GRSP 61st Session May 2017
Informal Document GRSP-61 -32

Review of GRSP-2017-13e
Proposal for amendments to R44
11/05/17

GRSP Working Document - GRSP-2017-13e

- Proposed supplement 13 to R44 (Netherlands)

Amend 6.2.2.

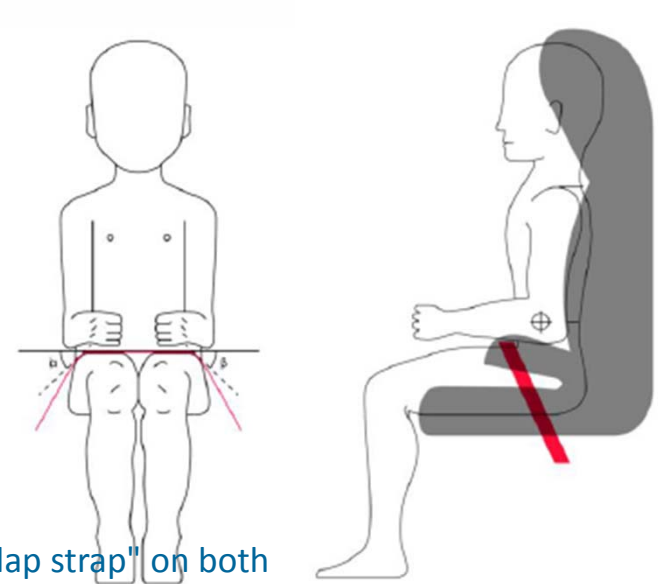
Clepa Proposal :

6.2.2. All restraint devices utilizing a "lap strap" shall positively guide the "lap strap" on both sides to ensure that the loads transmitted by the "lap strap" are transmitted through the pelvis. The assembly shall not subject weak parts of the child's body (abdomen, crotch, etc.) to excessive stresses.

Insert a new section : 6.2.3. 6.2.3. In the case of booster seats, the lap portion of the adult seat belt shall be positively guided on both sides to ensure that the loads are transmitted by the adult lap belt are transmitted through the pelvis. The positive guidance of loads over the pelvis shall be realised from the moment that the child is installed; the lap belt shall pass over the proximal thigh, just touching the fold with the pelvis. The angles α and β between the tangent line in which the belt touches the thighs and the horizontal shall be greater than 10° .
the thighs and the horizontal shall be greater than 10° .

Reason: "Lap strap" applies to any belt, including harness belts

Figure 1C
Standard seat belt configuration, for fitting session of par.6.2.12.

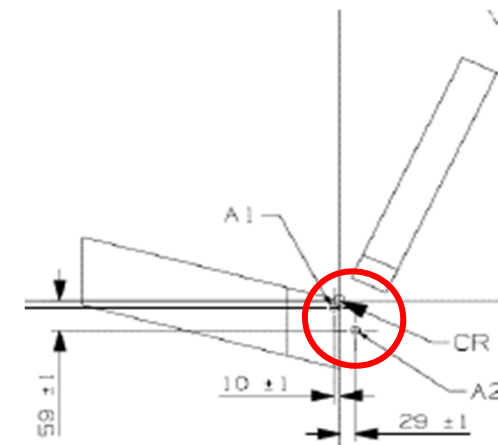
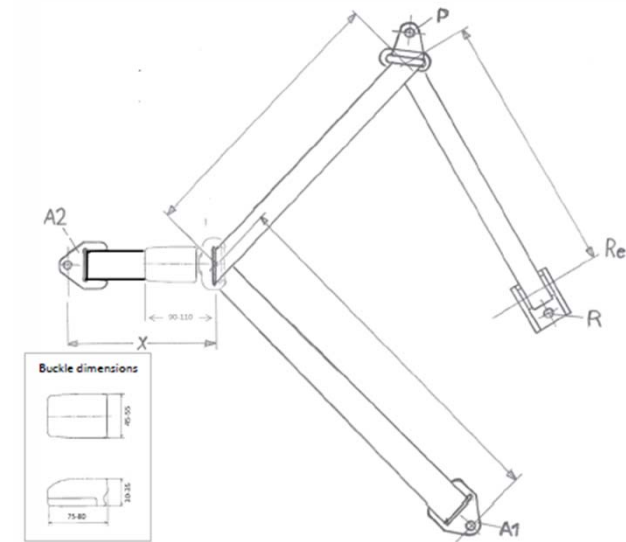
Clepa position:

- The benefit of this additional test is unclear
- Aside from one of 2 specific products we are not aware of issues in real world for the majority of CRSs .
- Technical Service Group has discussed this procedure and has reservations about its application in approval process
- The term “fixture points” needs to be defined / clarified .
- Need to test the procedure before it is adopted
